DOCUMENT CHANGE REQUEST

DCR number 421	Changes required for: N/A	Originator: aissa nehdi
Date: 2008/07/24	Date sent: 2008/07/24	Organisation: CNES
Status: IMPLEMENTED

Title:	Transistors Low Power NPN, based on type 2N2222A		
Number:	5201/002	Issue:	2

1.6.3 Chip Carrier Package (CCP) - 3 terminal

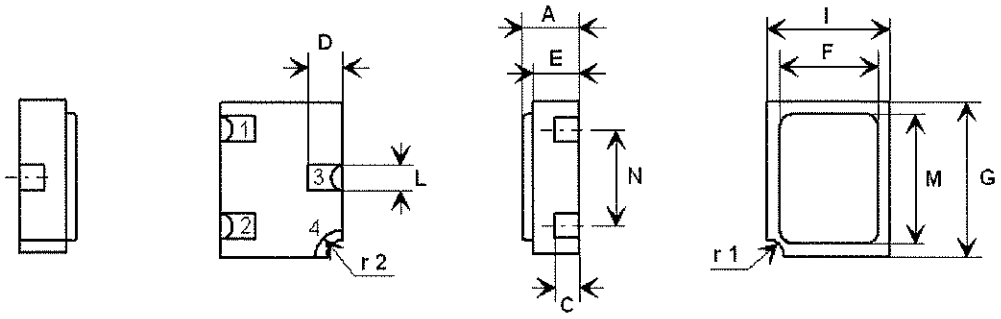
Variants 11 & 12 added (Chip Carrier Package CCP) 3 terminal

In order to incorporate the 2 new Variants, 11 & 12, the changes as shown in the modified attachment (see attached), shall be made to Paras 1.4.2, 1.5, 1.6.3 (new para), 1.7, 2.4.1 of 5201/002 issue 2. see attached

Symbols	Dimensions mm		Notes
	Min	Max	
A	1.15	1.5	
C	0.45	0.56	2
D	0.6	0.91	2
E	0.91	1.12	
F	1.9	2.15	
G	2.9	3.25	
I	2.4	2.85	
L	0.4	0.6	2
M	2.4	2.65	
N	1.8	2	
r1	0.3 TYPICAL		1
r2	0.56 TYPICAL		1

1. Terminal identification is specified by reference to the corner notch position where terminal 1 = emitter, terminal 2 = base, terminal 3 = collector, terminal 4 = shielding connected to the lid.
2. Applies to all terminals, 1, 2, 3 S
